has permission to re-activating permit# 060217 "Change of use single family to 2 units & 24x32 addition"

AT 90 CHESLEY AVE CB# 439 C014001 City of Portland

**City of Portland, Maine - Building or Use Permit Application**

ONE AND TWO FAMILY	PLAN REVIEW	CHECKLIST		
Soil type/Presumptive Load Value (Table R401.4.1)				
Component	Submitted Plan	Findings	Revisions	Date
<b>STRUCTURAL</b> Footing Dimensions/Depth (Table R403.1 & R403.1(1), (Section R403.1 & R403.1.4.1)	10" x 20" 4' min. 36" x 36" x 12" pad 10" wall <del>EIF wall system</del> CMU Blocks	OK		
Foundation Drainage, Fabric, Damp proofing (Section R405 & R406)	stone, drain, filter ? damp	OK	3/30	
Ventilation/Access (Section R408.1 & R408.3) Crawls Space ONLY	? 2" slab foam spec.	OK	3/30	
Anchor Bolts/Straps, spacing (Section R403.1.6)	?		OK	3/30
Lally Column Type (Section R407)	column.	OK		
Girder & Header Spans (Table R 502.5(2))	?			
Built-Up Wood Center Girder Dimension/Type	?			3/30, rns dist see spec OK
Sill/Band Joist Type & Dimensions	4x6 PT sill			OK
First Floor Joist Species Dimensions and Spacing (Table R502.3.1(1) & Table R502.3.1(2))	N/A			OK
Second Floor Joist Species Dimensions and Spacing (Table R502.3.1(1) &

Jim Dongo In-Law Apartment Addition  
 ATTN: Jeanne 48 Chesley Ave  
 Balcony Deck Framing detail

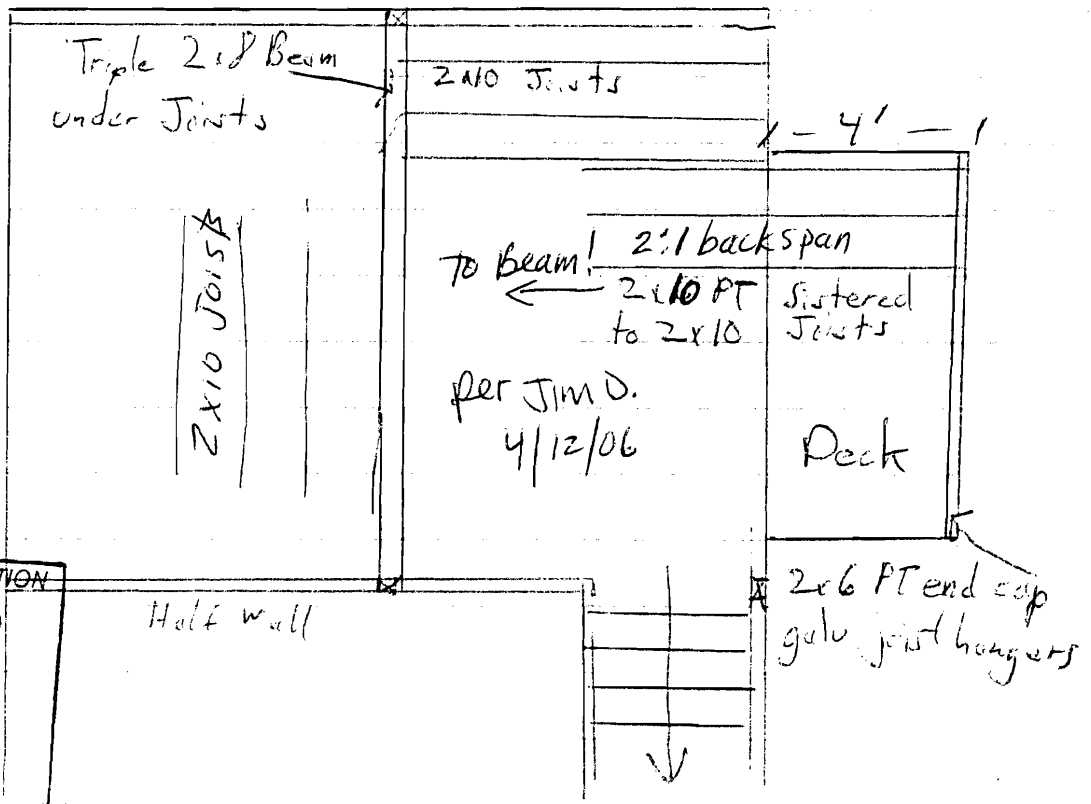
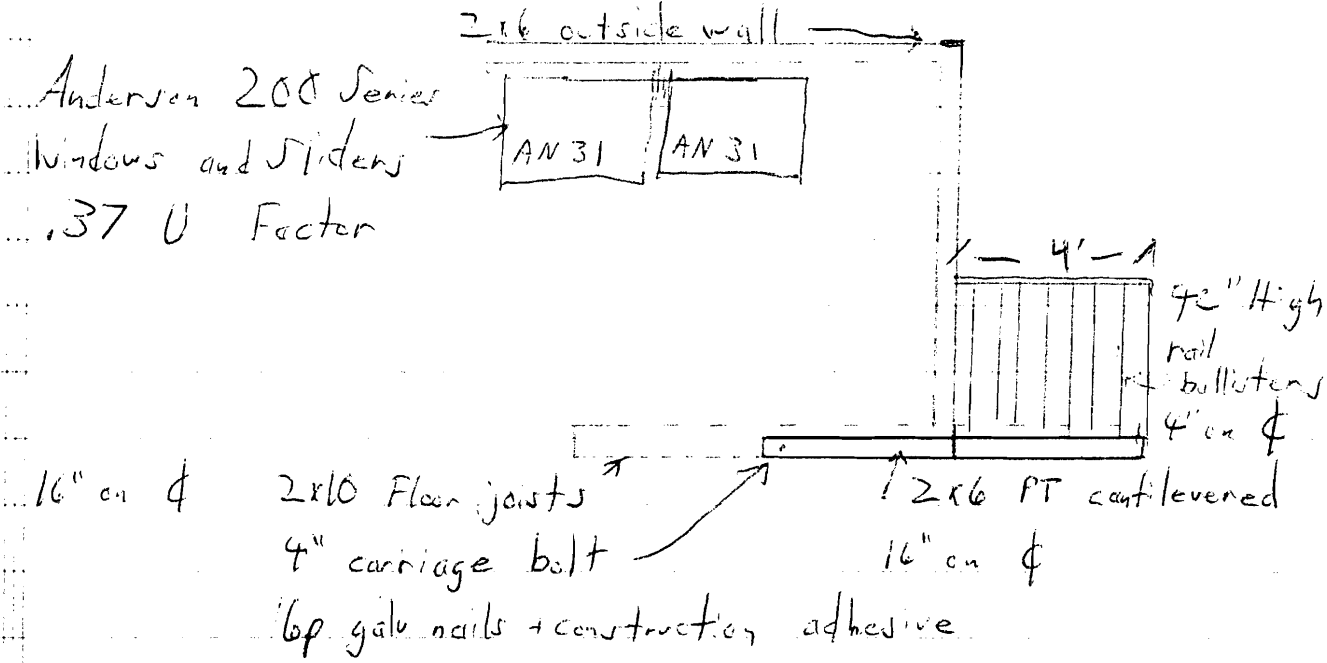
4/3/2006-jmb: Received plans for cantilevered balcony framing. Called Jim Dongo due to framing spans not meeting code. He will provide revisions and I will check w/Tammy on a plan she recently inspected.

Type of Heating System	Radiant Floor FHW	OK
<b>Means of Egress</b> (Sec R311 & R312) Basement	NA	
Number of Stairways	1	
Interior		
Exterior		
Treads and Risers (Section R311.5.3)	7 3/4" max Rise ? winder 10" min tread detail	
Width (Section R311.5.1)	36" min	
Headroom (Section R311.5.2)	6'8" min	
Guardrails and Handrails (Section R312 & R311.5.6 - R311.5.6.3)	? Half wall Ht.	36 min OK 3/30
Smoke Detectors (Section R313) Location and type/Interconnected	?	per code OK 3/30
Draftstopping (Section R502.12) and Fireblocking (Section R602.8)	? "	OK
Dwelling Unit Separation (Section R317) and IBC - 2003 (Section 1207)	? "	OK per code
Deck Construction (Section R502.2.1)	? "	details submitted 4/3/06 w/ REVISIONS 4/12/06 OK

4/12/2006-jmb: Spoke w/Jim D. For detail on cantilever balcony, he will use 2x10 pt sistered to existing 2x10 joists 16" oc, ok to issue when site plan is approved.
